## HISTORIC AND DESIGN REVIEW COMMISSION

February 01, 2017

Agenda Item No: 16

**HDRC CASE NO:** 2017-038  
**ADDRESS:** 5102 S PRESA ST  
**LEGAL DESCRIPTION:** NCB 7629 BLK 4 LOT N 70.04 FT OF 1  
**ZONING:** C-2, MC-2, RIO-5  
**CITY COUNCIL DIST.:** 3  
**APPLICANT:** TJ Hobbs  
**OWNER:** Haubstone Corporation  
**TYPE OF WORK:** Install deck and modify roof; modify door fenestration  
**REQUEST:**

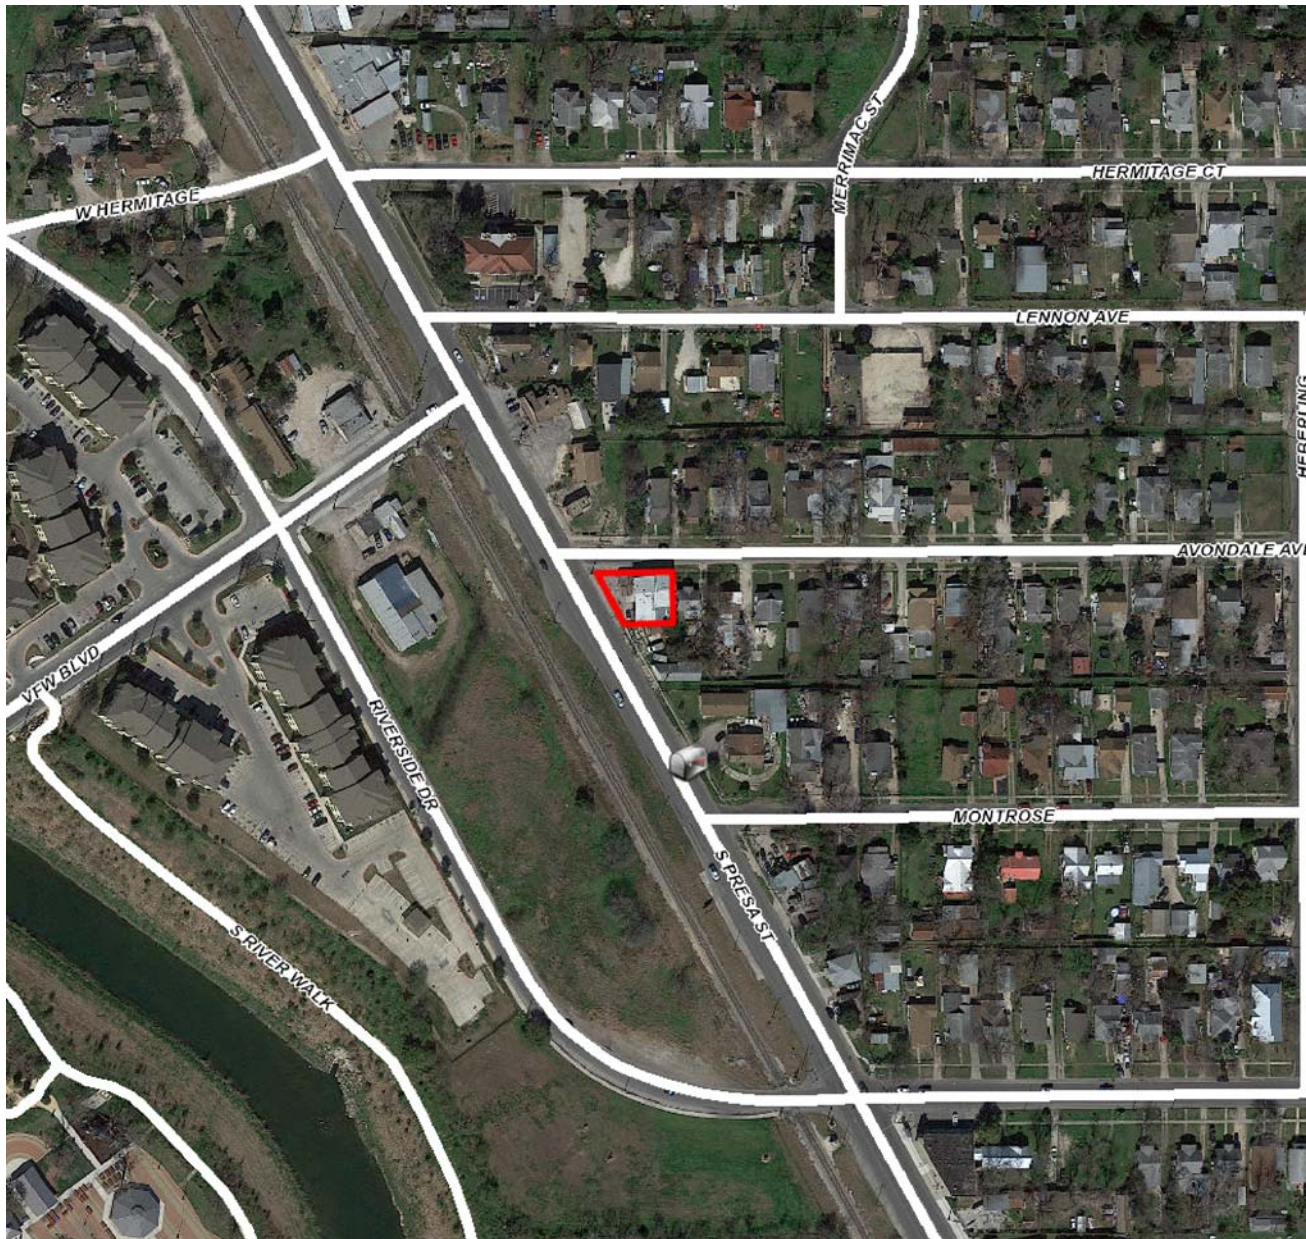
- b. The proposed new second-story deck will be replacing a gabled roof form over an existing carport. The deck is at the same height as the existing carport and would include a 4' wrought iron railing. According to the UDC Sec. 35-676, distinguishable original qualities of a building shall not be destroyed and alterations should be compatible with the size, scale, color, material, and character of the property, neighborhood or environment. The property is seen on the 1944 Sanborn in a smaller footprint than what exists currently. Staff found a photo from 1983 showing the building with the footprint seen on the 1944 Sanborn with a front gable roof. Staff finds the proposal to modify the gable roof form would not be consistent with the UDC.

- c. There is an existing door frame behind the existing siding on the left façade. The proposed new pedestrian door would be installed in that existing door frame, and the door would match the existing front pedestrian door that a window with 9 dividing lights. According to the UDC Sec. 35-676, distinguishable original qualities of a building shall not be destroyed and alterations should be compatible with the size, scale, color, material, and character of the property, neighborhood or environment. Staff finds the proposal to install a door in the existing frame consistent with the UDC.

Staff recommends approval of installing the door in the existing frame based on finding c.

Staff does not recommend approval of modifying the roof form based on findings a through b.

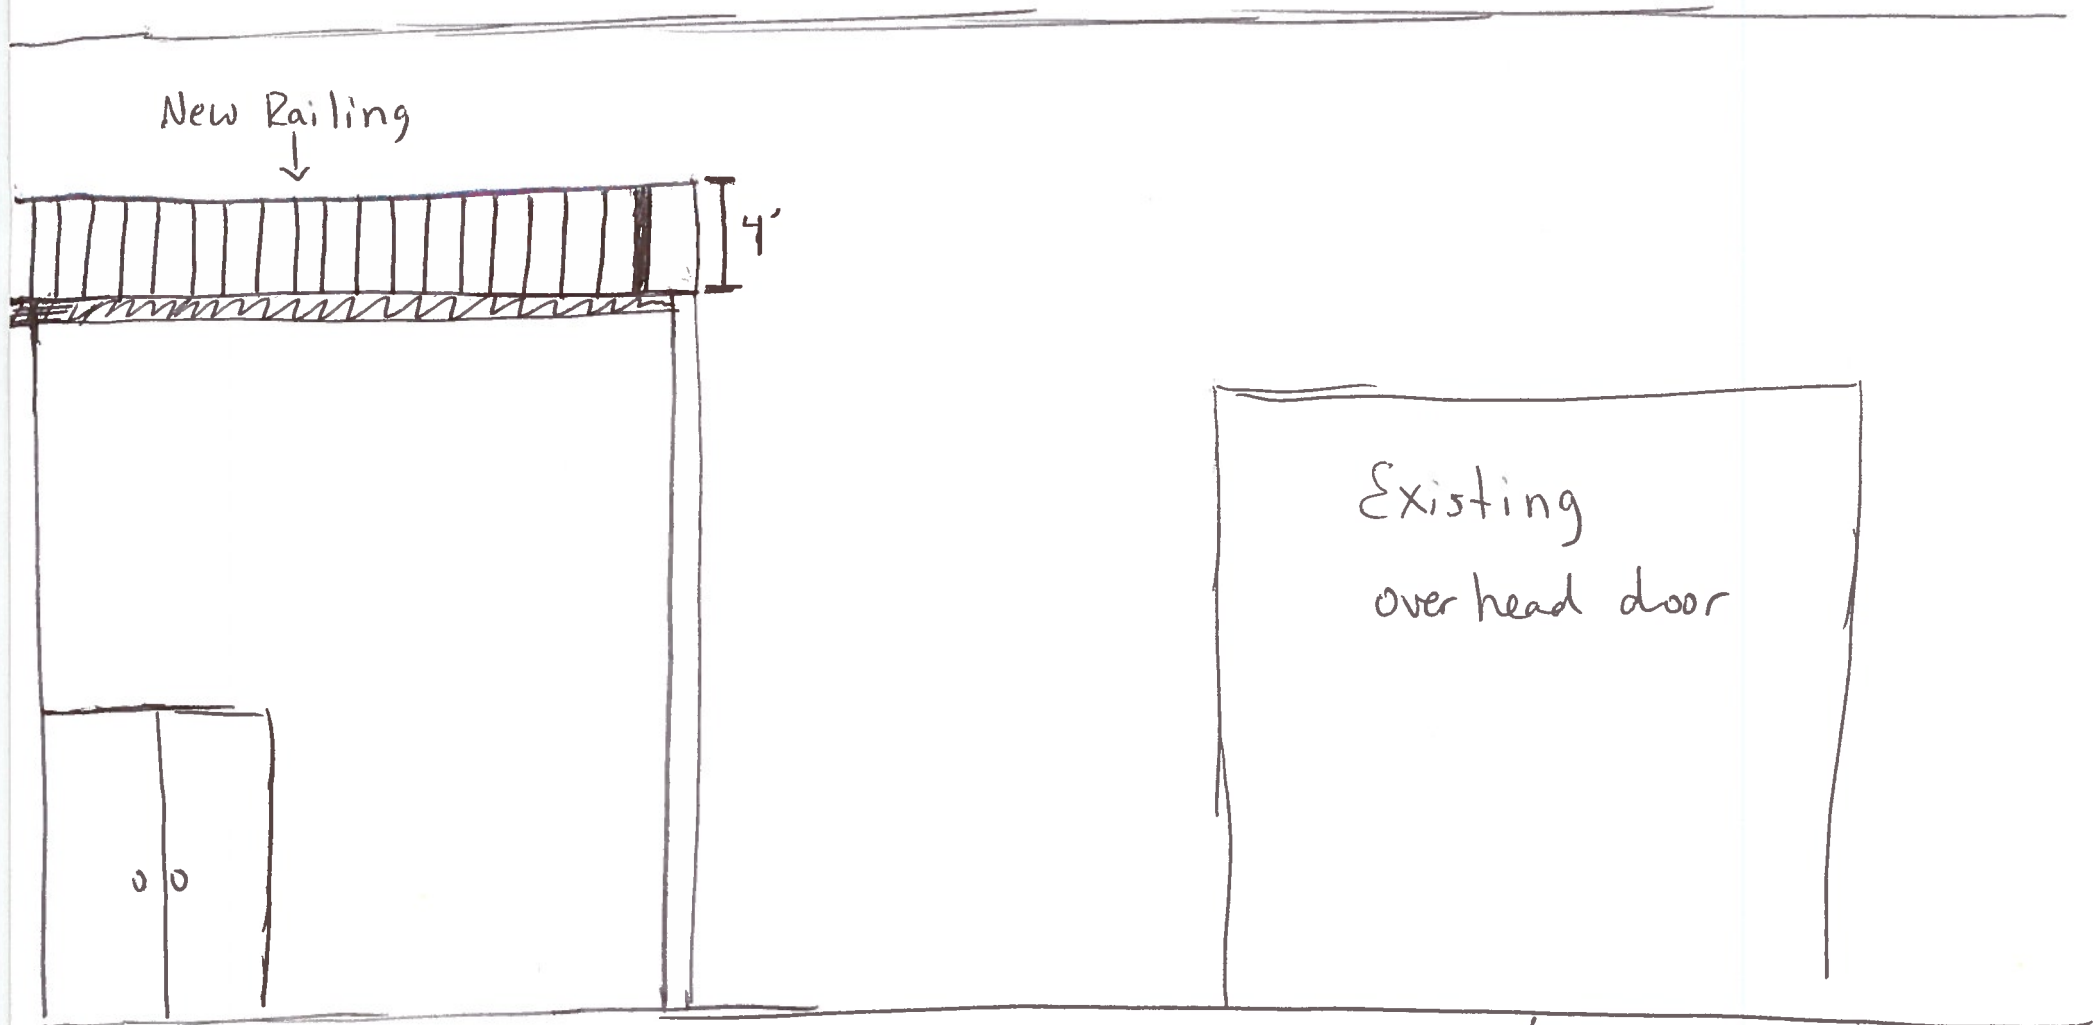
**Permanent Repairs:** We want to restore the deck back to the way it was originally built by removing the hip part of the roof, This was added after the deck was built to make it a carport instead of a deck. There is a beautiful view of the Riverwalk extension which is about 1 block away and also downtown. The deck will be permanently bolted to the building with 1/2" galvanized bolts, washers and nuts. Six sets. The railing will be reinstalled and built to code. The original deck will be saved as is with the exception of any damaged or rotted wood and building code requirements. The rock will be removed from the front of the building and replaced with 12" Hardy board horizontal siding. The rock is only under the deck. The balance of the front will have 4x8 vertical Hardy board cement siding which is the same siding that is on the north side and some of the east side of the building. The balance of the building is 16" cement block walls.

The deck will be permanently bolted to the building with 1/2" galvanized bolts, washers and nuts. Six sets.

The railing will be reinstalled and built to code. The original deck will be saved as is with the exception of any damaged or rotted wood and building code requirements.

The rock will be removed from the front of the building and replaced with 12" Hardy board horizontal siding. The rock is only under the deck. The balance of the front will have 4x8 vertical Hardy board cement siding which is the same siding that is on the north side and some of the east side of the building. The balance of the building is 16" cement block walls.
